Project	<b>IEEE 802.16 Broadband Wireless Access Working Group</b> < <a href="http://ieee802.org/16">http://ieee802.org/16</a> >		
Title	MAC Frame numbering and synchronization		
Date Submitted	2006-07-18		
Source(s)	Mariana Goldhamer Alvarion 21, HaBarzel Street Tel Aviv, Israel	Voice: Fax: <a href="mailto:mariana.goldhamer@alvarion.com">mailto: mariana.goldhamer@alvarion.com</a>	+972 544 22 55 48 +972 3 6456241
Re:	IEEE 802.16h-06/015 – Working Group Review		
Abstract	Clarifies the MAC Frame sync and numbering issues

## **MAC Frame numbering and synchronization**

**Figure: The first 4 slots of the Control Channel**

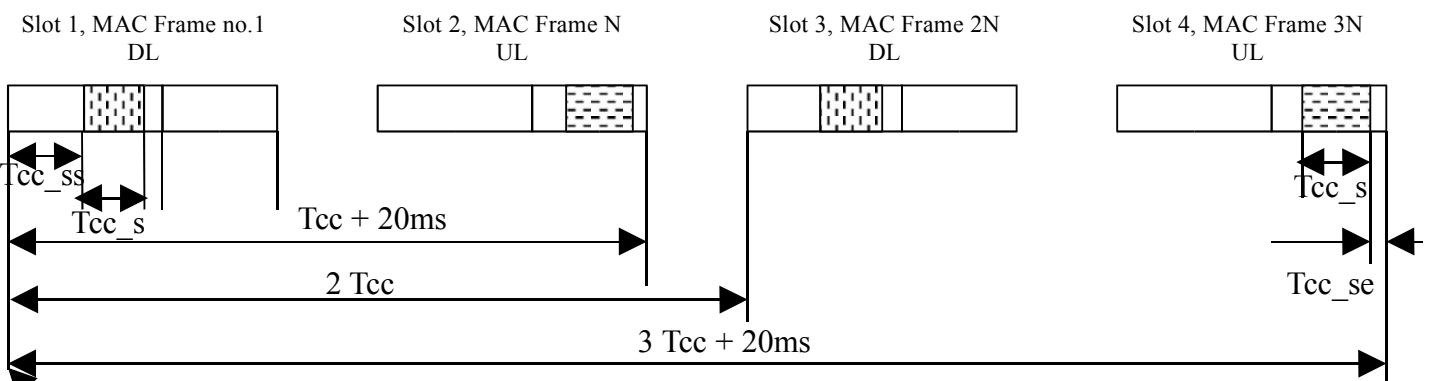
The first 4 slots of the Control Channel are shown in the fig. hy.

The positioning of the DL/UL Control Channel slots is done in a way that will keep their DL/UL characters for a MAC Frame duration of 5,10 and 20ms. The interval between two consecutive DL slots is  $2T_{cc}$  and is defined in Chapt.10.5.2.
